Notice of Intent

Sundry ID: 2778457

Type of Action: APD Change

**Procedure Description:** OXY USA Inc. respectfully requests approval to amend the subject well(s) AAPD to update the production string cement from 13.2ppg Class H/Poz slurry to a 13.3 Class C/Poz slurry. See the attached drill plan revision summaries and lab test for reference. No surface hole changes or additional disturbance are related to this sundry.

**UCA Compressive Strength**

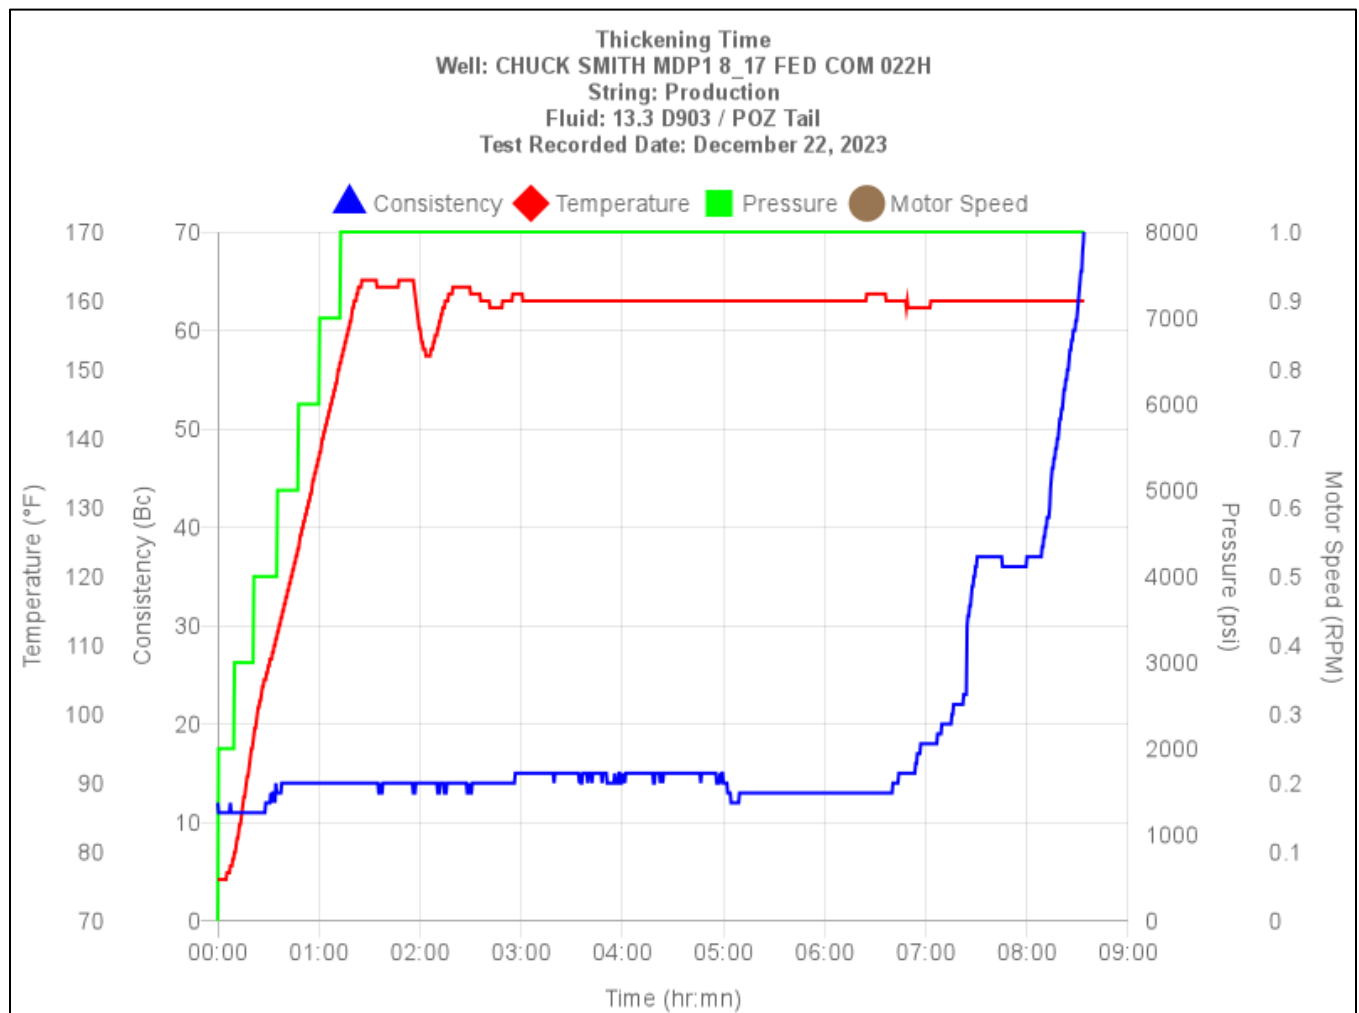
Note: When compared to the Class H / Poz system(s), the Class C / Poz slurry achieved earlier (faster) compressive strength development.

Class C / Poz: 500 psi 06:10 hr:mn

Time	Compressive Strength	Temperature
03:58 hr:mn	50 psi	160 degF
06:10 hr:mn	500 psi	160 degF
24:00 hr:mn	1069 psi	160 degF
48:00 hr:mn	1241 psi	160 degF
72:00 hr:mn	1294 psi	160 degF
Machine S/N:	640
